# FIRE SAFETY INSPECTION REPORT

**NINE 2 NINE INTIMATES LIMITED**

**ACCORD ID: 12867**

**Date: 18 June, 2017**

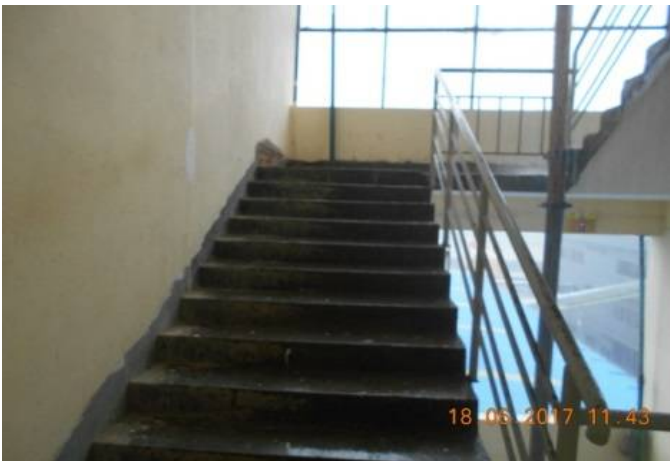
6	Fire Rated Construction	Unsealed penetrations and openings are located in the exit stair enclosures <b>Location:</b> South-East side stair.	Seal all penetrations and openings in exit stair enclosure walls to maintain the fire separations.	Within 3 months
---	-------------------------	--	--	-----------------
